**PLANNED UNIT DEVELOPMENT, SUBDIVISION,
& SIDEWALK WAIVER STAFF REPORT Date: December 15, 2005**

DEVELOPMENT NAME Beard Equipment Company

SUBDIVISION NAME North Beltline Commercial Park Subdivision,
Resubdivision of Lots 1 & 3

LOCATION 2480 and 2490 East I-65 Service Road North
(Southeast corner of East I-65 Service Road North
and Industrial Street West)

SITE PLAN

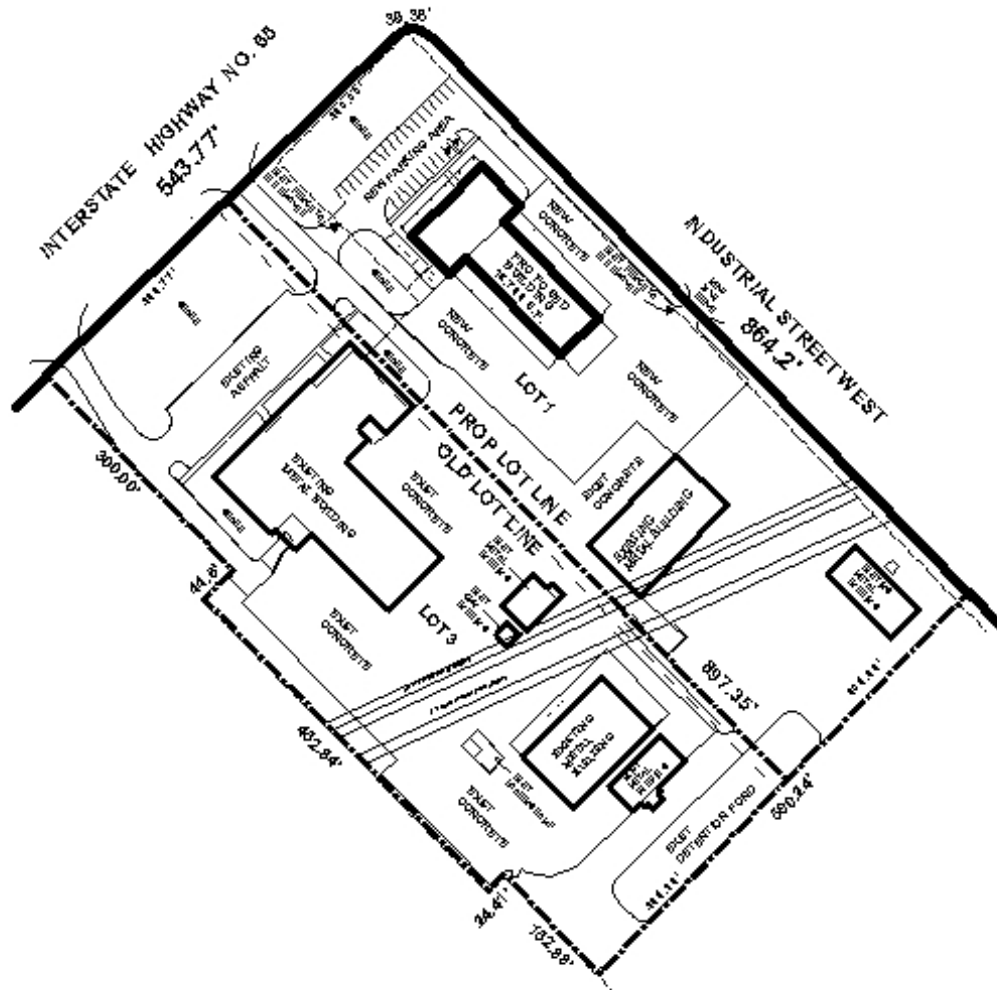
The site plan shows existing improvements remaining, and the addition of a new building on Lot 1, which would be surrounded by new concrete and parking. The site illustrates both existing driveways to the service road remaining, and the creation of a new driveway to Industrial Street West; there appears to be a separate existing curb cut to Industrial Street West, which must be removed if the proposed one is built, and in its place should be installed curb, gutter, and landscaping materials in compliance with Section IV.E.3 of the Zoning Ordinance.

Because the precise use of the building has not been specified, it is not evident whether parking provisions are adequate. There are 31 new spaces shown for a building of 15,736 square feet; if this building were entirely used for offices and auto repair, 53 spaces would be required. Thus, the applicant should provide sufficient parking or indicate whether a significant portion of the building will be for a use that requires less parking.

The site currently shares access with the lot to the Southeast, at the corner of Industrial Street West and Berkley Avenue. Access between lots is permitted only with Planned Unit Development approval; thus, either the third lot must be included in the Planned Unit Development and the site brought into compliance with the Landscaping, Tree Planting, and Buffering Requirements of the Zoning Ordinance, a physical barrier prohibiting access between these sites must be erected. If the third lot is brought into the application, additional notification and fees will be required, as well as revised drawings for the PUD and, if sought, Sidewalk Waivers along Berkley Avenue and the remainder of Industrial Street West.

Regarding the Sidewalk Waiver request, the applicant is seeking waivers along the frontages of East I-65 Service Road North and Industrial Drive West. The applicant states that there is a ditch along Industrial Street West, which prohibits construction of a sidewalk to city standards; this assertion is supported by the cross-section provided. The applicant also requests a waiver along East I-65 Service Road North, stating that there are no sidewalks adjacent to the property, and that there would be drainage problems due to elevation and existing inlets.

The construction of sidewalks would be required on properties adjacent to the site, were they to be redeveloped, and thus their current absence is no reason to waive the requirements along East I-65 Service Road North. Furthermore, it is difficult to see how the sidewalk would be more to blame for drainage problems than the applicant's totally paved site. Nevertheless, three sidewalk waivers have been approved on nearby properties fronting the service road, and granting this one may be appropriate given that the area is not inviting to foot traffic for other reasons, including the nearness of interstate traffic, the distance between destinations, and the unlikelihood that a sidewalk would eventually connect with other sidewalks.

Planned Unit Development Based on the preceding, it is recommended that the application be held over until the January 5th meeting, to allow the applicant to include the lot to the Southeast in the PUD application. Revised drawings, additional fees, and mailing labels must be received by Urban Development by December 19th to be considered.

Subdivision Based on the preceding, it is recommended that this application be held over until the January 5th meeting, to coincide with the PUD hearing.

Sidewalk Waiver Based on the preceding, it is recommended that this application be held over until the January 5th meeting, to allow the applicant to submit additional sidewalk waiver requests, if desired, and to coincide with the PUD hearing.
